Karen Bokor, B.S., M.Arch.  
**DESIGN CONSULTANT**

## HISTORICAL ANALYSIS AND DESIGN REVIEW:

**Property Address:** 55 S Riverview Street  
Dublin, Ohio 43016

Views of existing Garage:

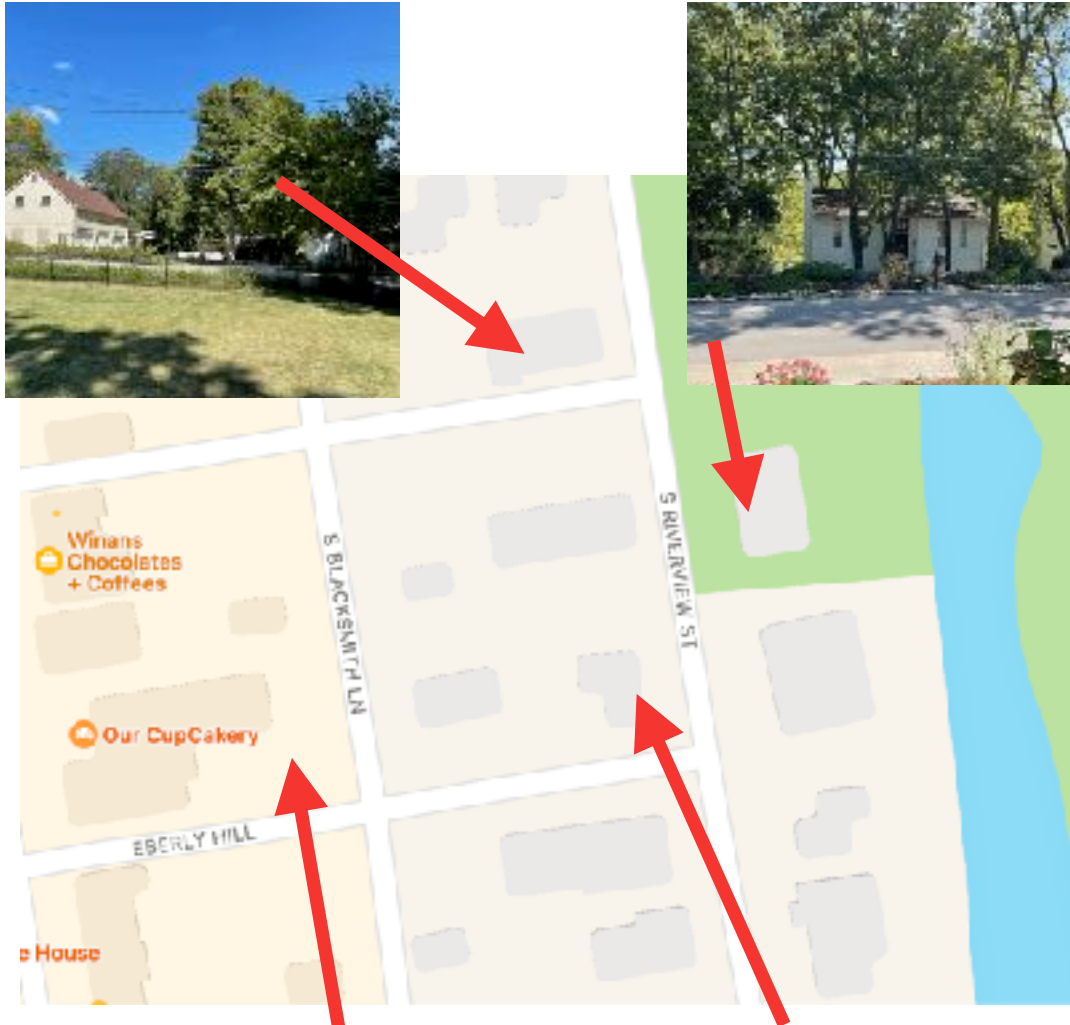
Below are views of the existing garage. There is no significant impact to the street and the structure is not very visible from the sides or front of the property, only from S Blacksmith Lane.

This structure, while currently classified as Contributing, could easily be replaced with another garage, attached or detached, and maintain all characteristics that currently categorize it as Contributing. For this reason I would consider it Non-Contributing. I would, however, consider that this portion of the site is the appropriate location for a garage and would support this request for the designation to be changed to Non-Contributing providing it is done with the approval of a new garage.

- Consideration of the reclassification of the garage from Contributing to Non-Contributing should be done with reference to the proposed new garage facade.
